S10 Editor's report **Proposed Section 10 amendments 2022**

S10 Editor's report, November 2022

Gate distance from pylons and pylons stadium position in slalom competition

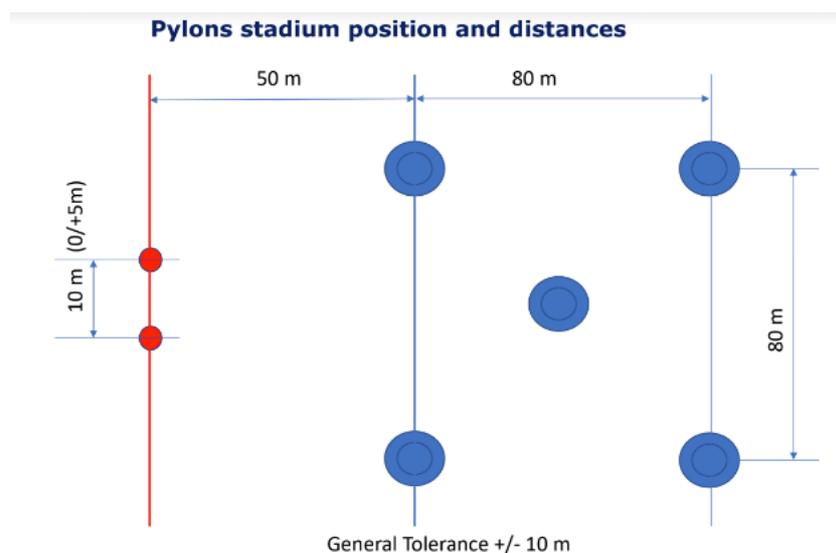
None, it is adding a new paragraph for annex 7 or 8.

The distance from the gate to the pylons is not specified in annex 7 or 8.

Distance about 50 meters from the gate to the axis of pylons and 80m between each pylon in a square chape, one in the middle.

Tolerances as defined in the provided diagram.

*We suggest a distance about 50 meters from the gate *to the axis of pylons will be a great choice. **And 80m between each pylon** in a square chape, one in the middle.
